# Observations on the Southern Company Draft Base Isolation Guidelines Report

Thomas Weaver, Weijun Wang, and Jose Pires  
Office of Nuclear Regulatory Research, Nuclear Regulatory Commission

July 24, 2024  
Advanced Reactors Stakeholders Meeting

Guidelines for Implementing Seismic Base Isolation in Advanced Nuclear Reactors,  
Southern Company, Document Number SC-  
SND8932-001 Rev A, May 2024

From Table 3.1 in the Draft Report

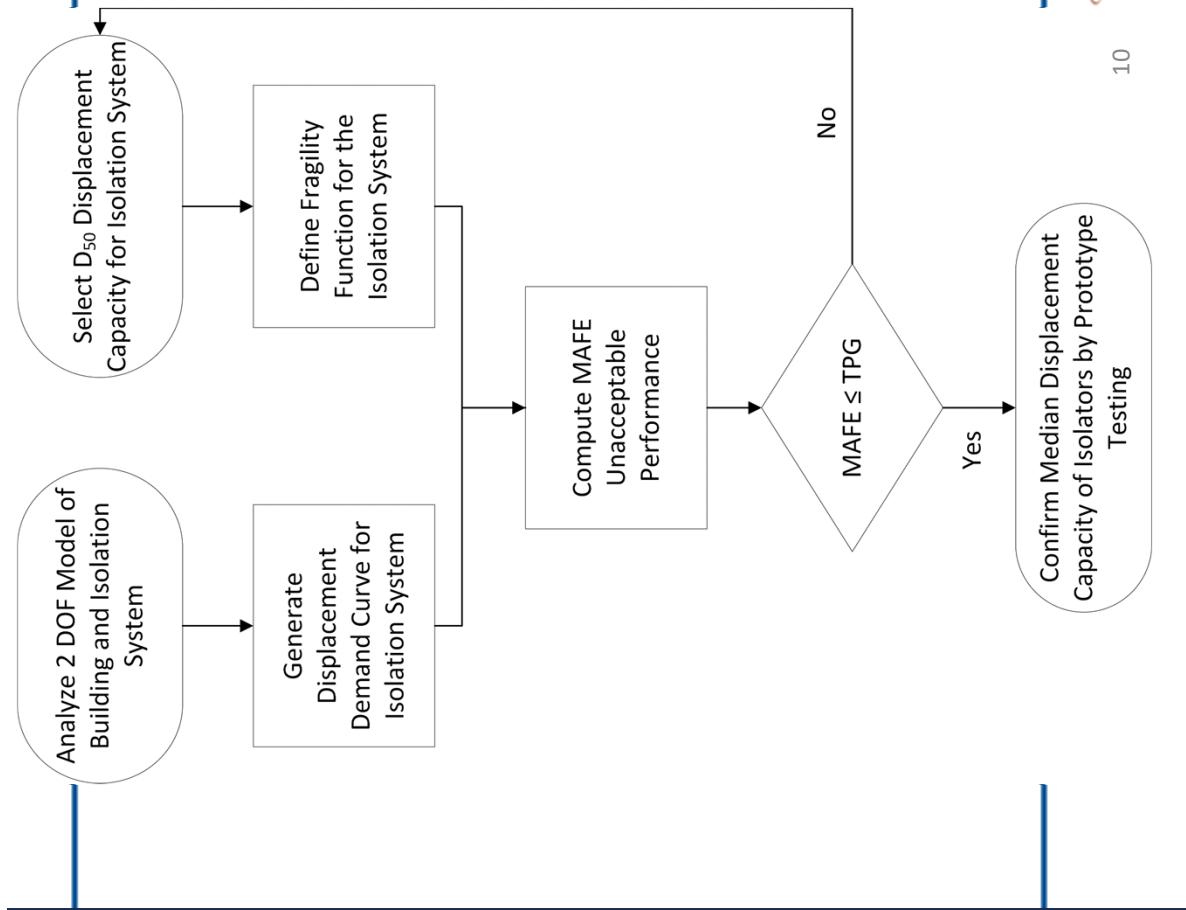
- Consider adding discussion on how and why performance expectations vary from ASCE 4 Table 12-1.
- Expand on meaning and clarification of terms in table,
  - Mean maximum displacements (DB) and their use
  - TPG axial force (TPG)
  - TPG velocity (TPG)
- E.g., terms denoting response demands, viscous dampers demands and terms referring to isolators' capacities
